PROPOSED CHANGE NO. 8

SOUTHWEST EXPERIMENTAL FAST OXIDE REACTOR

OCTOBER 16, 1971

Re: LICENSE DR-15

Figure 1. Limits for Poison Slug Worths

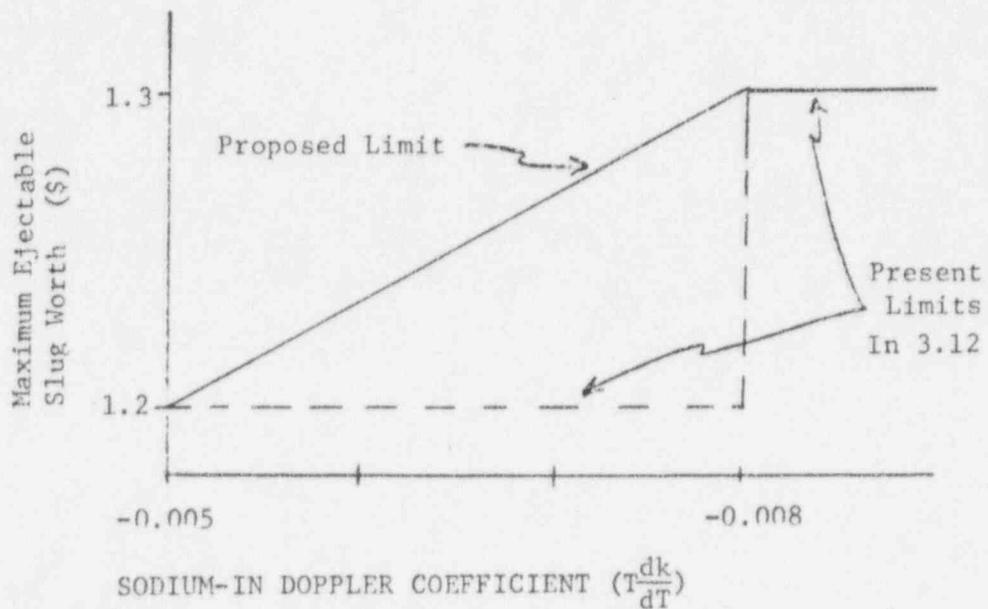
perform the superprompt critical transients with the maximum permissible poison slug worth consistent with safety considerations. Therefore, it is proposed that the present limit of 1.2\$ for any Doppler coefficient with a magnitude of less than 0.008, be changed to permit a linear interpolation between the present values for the limiting slug worth as a function of Doppler coefficient. This would result in a limiting slug worth of 1.26\$ for a Doppler coefficient of -.0069. This method of determining the limit will provide equivalent margins with respect to the design transient for any acceptable value of the Doppler coefficient, as discussed below. The observed values of the dynamic slug worth will be used for comparison to the limits as discussed on page 3 of Ref. (3).

Figure 1 compares the proposed limits for slug worth to the present limits.

FIGURE 2: POWER DURING SUPER-PROMPT CRITICAL TRANSIENTS

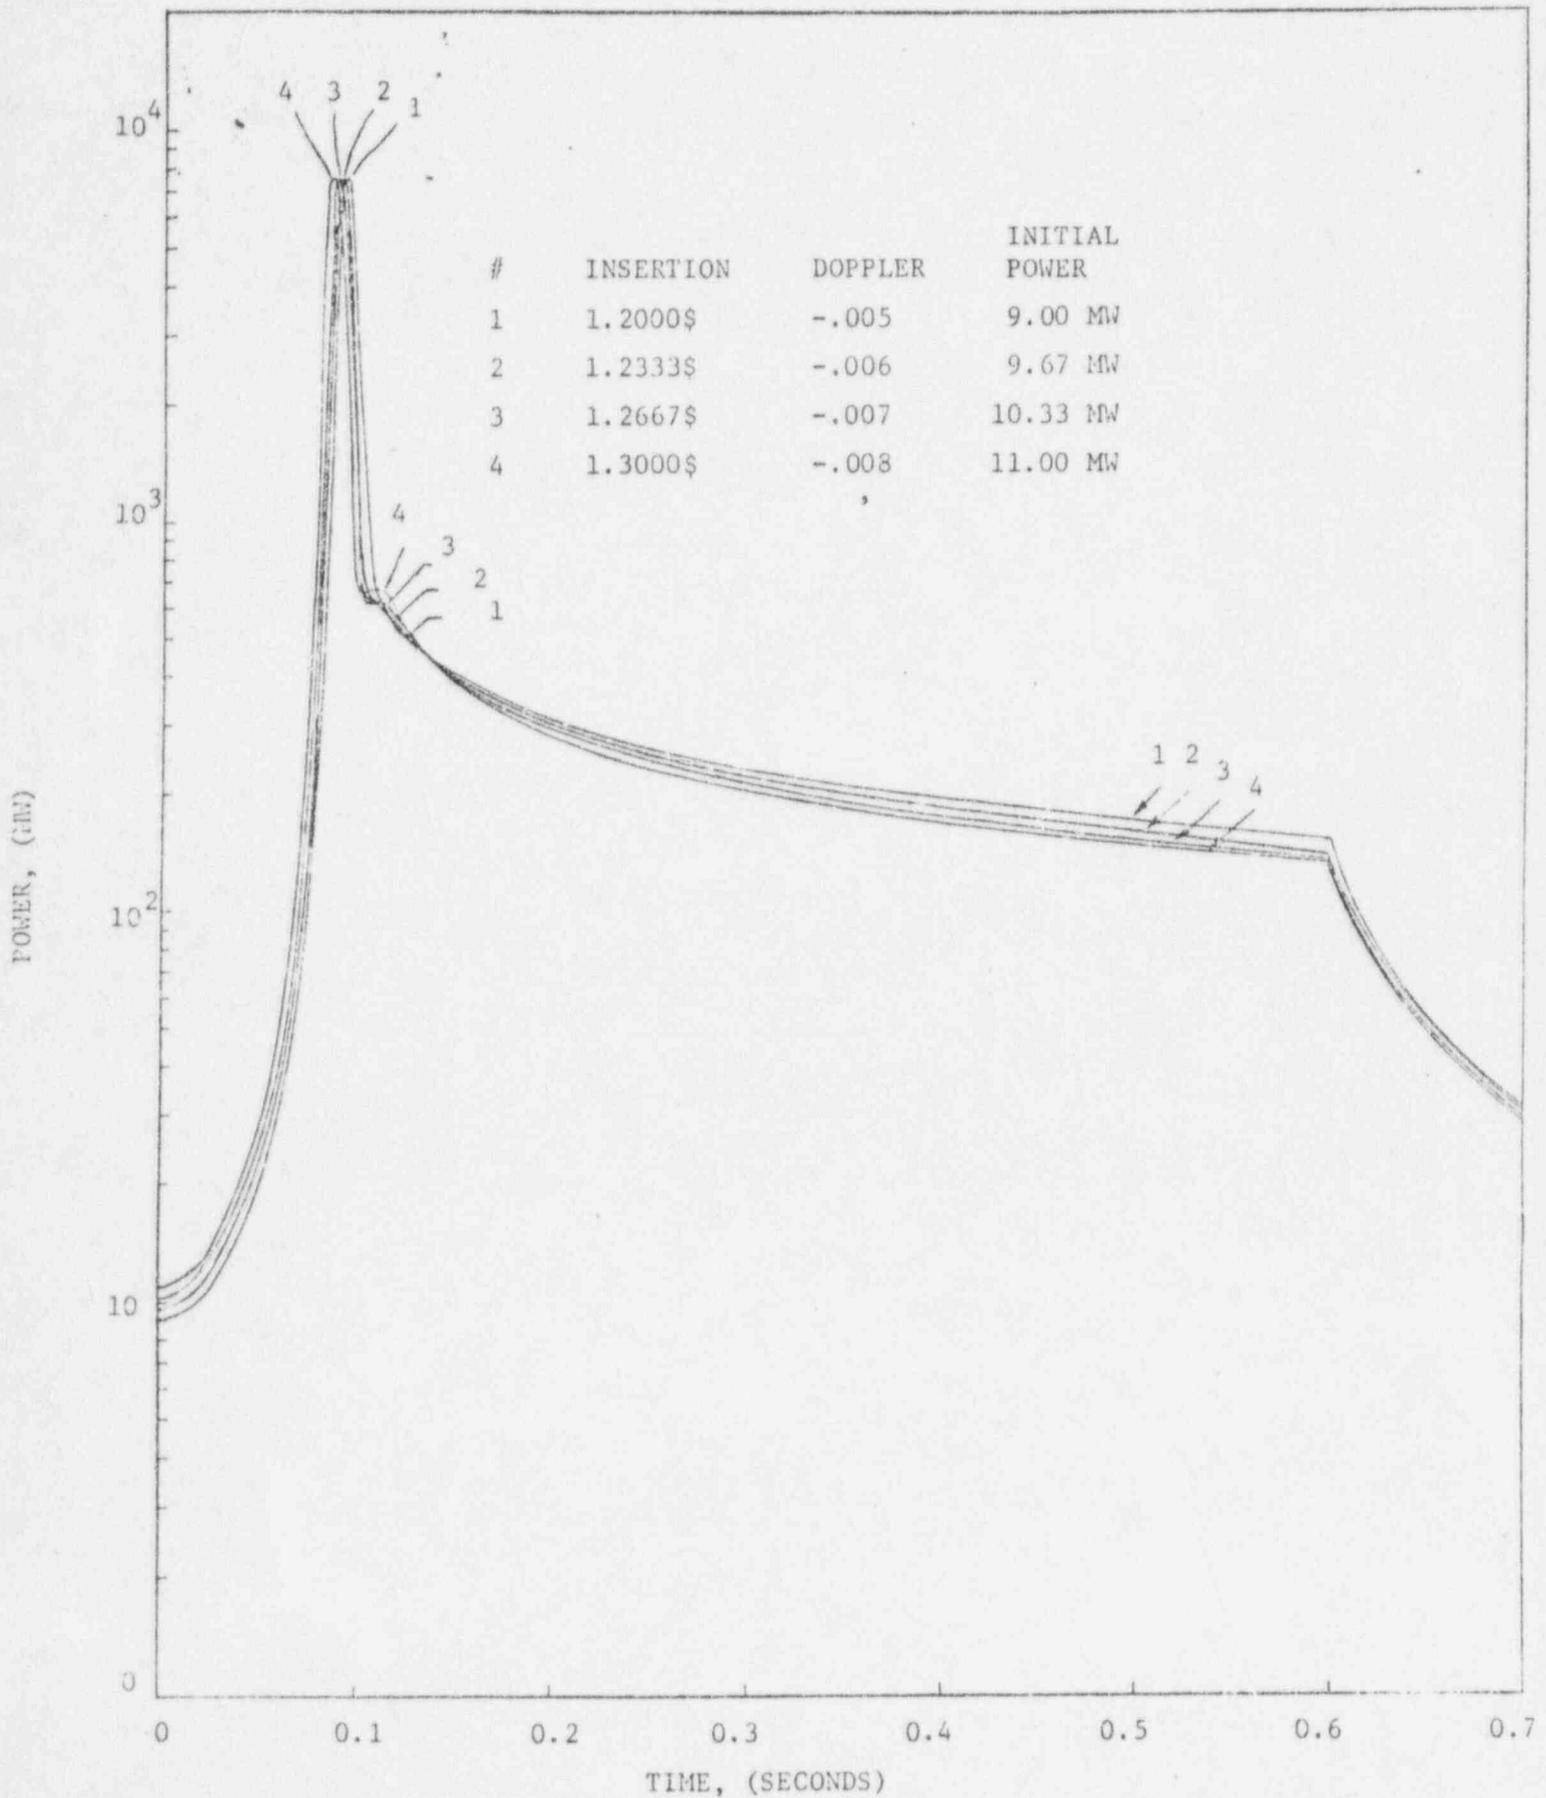
The calculated values of power and increase of the average fuel temperature are given in Figures 2 and 3 for transients with Doppler coefficient values of -0.005, -0.006, -0.007, and -0.008, and with reactivity insertion values corresponding to the proposed limit.

From these figures it can be seen that the proposed limits for intermediate values of the Doppler coefficient provide an envelope for transient tests which is consistent with the present limits for Doppler coefficients of -0.005 and -0.008.

It should be noted that the values obtained from Figures 2 and 3 represent the maximum values since they are based on the maximum initial power level consistent with the core loading limit of .50\$ and on start of reflector movement (scram) at 0.600 seconds. Thus the proposed limits provide margins with respect to the design transient which are equivalent to the margins provided by the present Technical Specifications for Doppler coefficients of -0.005 and -0.008.

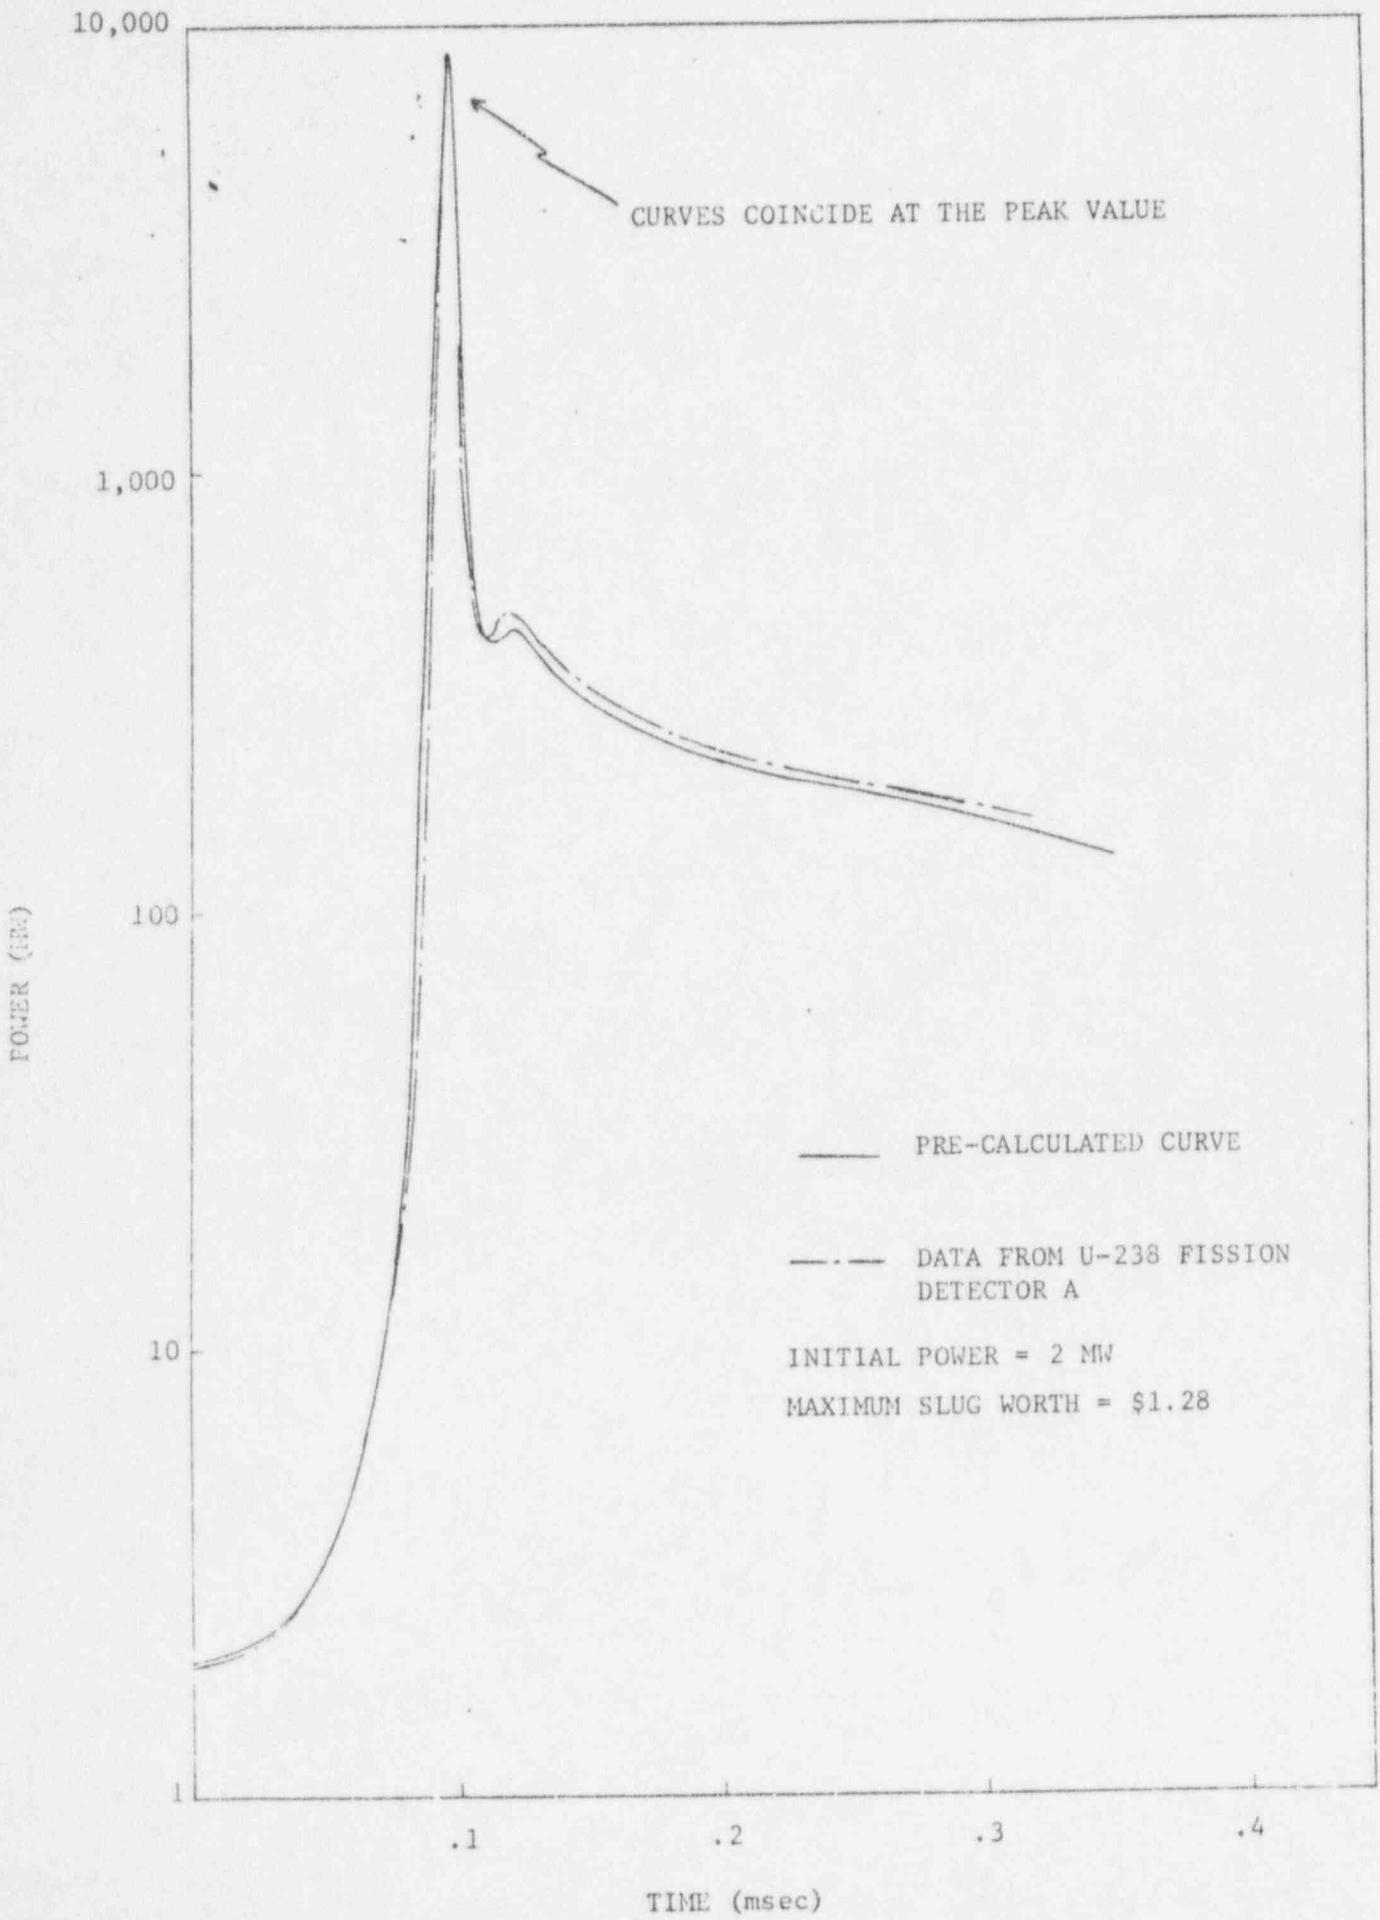
The data for superprompt transient No. 2 are plotted in Figure 4. Non-Doppler feedback coefficients contribute about 12 percent of the total feedback during the transient. This comparison provides assurance that the results of transient tests for Core II can be accurately predicted by use of the available analytical tools and test data.
